CERTIFICATE OF APPROPRIATENESS

Property: 1108 E 14th Street, Lot 2, Block 118, North Norhill Neighborhood Subdivision. The property includes a historic 1,315 square foot, one-story masonry single-family residence and detached garage situated on a 5,200 square foot (104' x 50') interior lot.

Proposal: Alteration – Porch

EXISTING

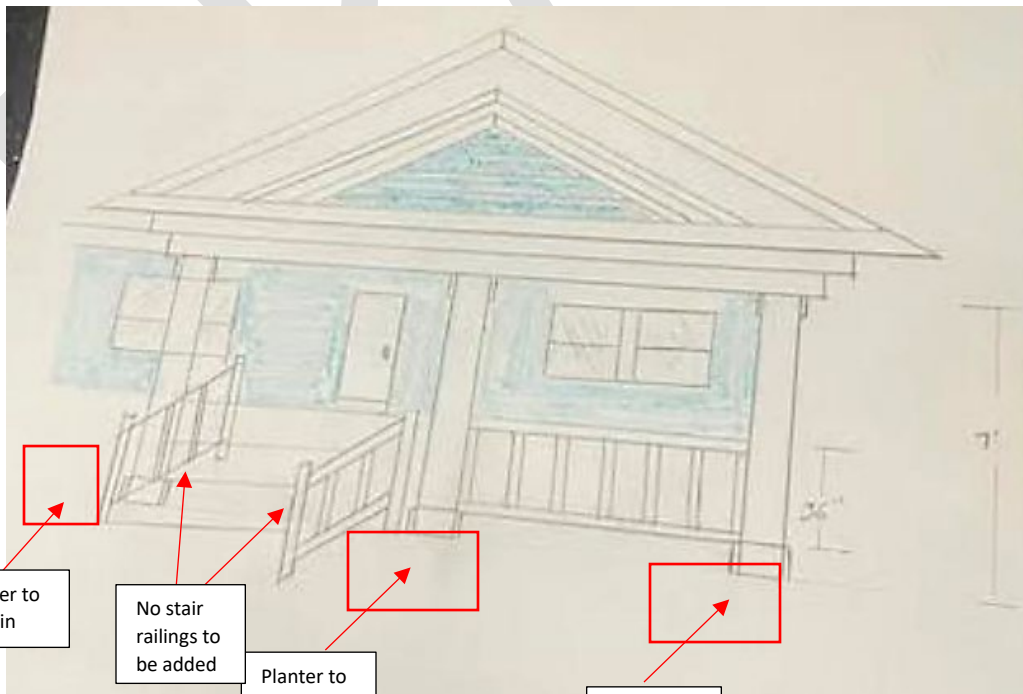
- Metal columns to be replaced with wood columns.
- Wood railing to be added between columns.
- **Staff requires paint to be removed from masonry.

Recommendation: Denial of COA and issuance of COR requiring removal of paint on original brick surfaces and allowing for the proposed alteration to the porch, columns, and railings. Consult with staff for proper paint removal strategies.
